New Park at 44 Jackes Avenue

What We Heard: Phase 1b (Design Options) Engagement Summary

April 2022

Design Option A

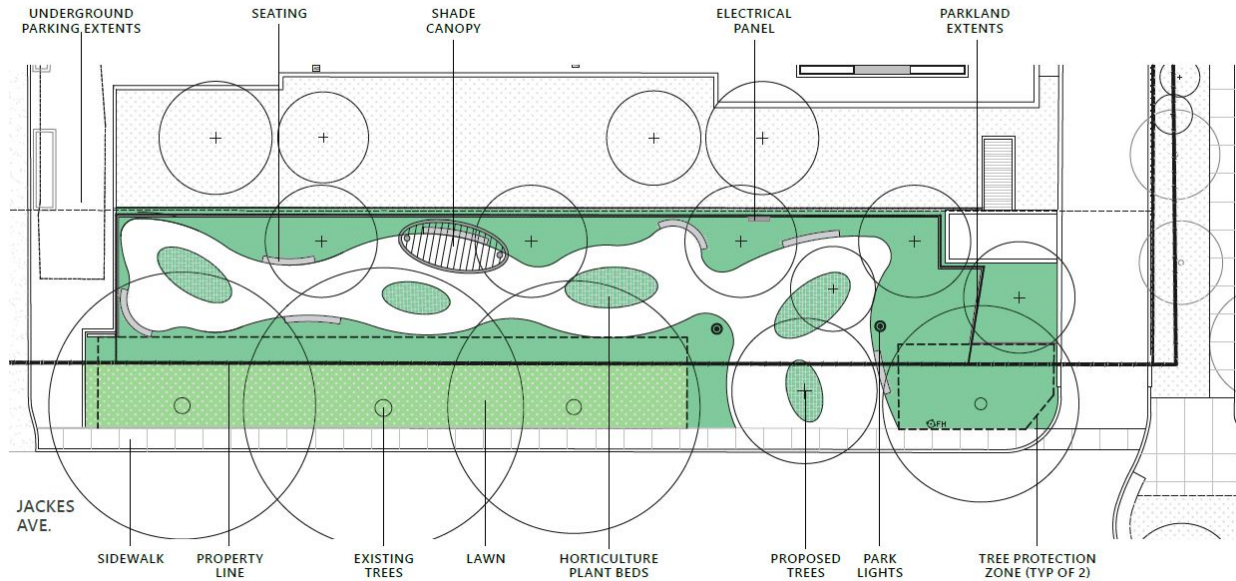
- Concerns that the wooden wall (solid) would be too intrusive, and something that was more permeable would be preferred so that the park would not see too private.

- Comments from nearby school that expressed preference for Option A, as it would allow for better supervision of youth who may use the new park.
- Questions on where the entrance to the park would be located, and if there is a service entrance. Staff note that the entrance will be to the east end of the park because that is the only location where there is a gap where trees cannot be planted.

- I feel the shade structure in design 1 is asking for graffiti! It feels like a wall in a time when we are trying to tear down walls. The second option has lovely movement to it, in the words of Frank Gehry, movement is emotion. The second design is more interesting and flowing and softer. With all the hard lines in the city, it's nice to see some softness.
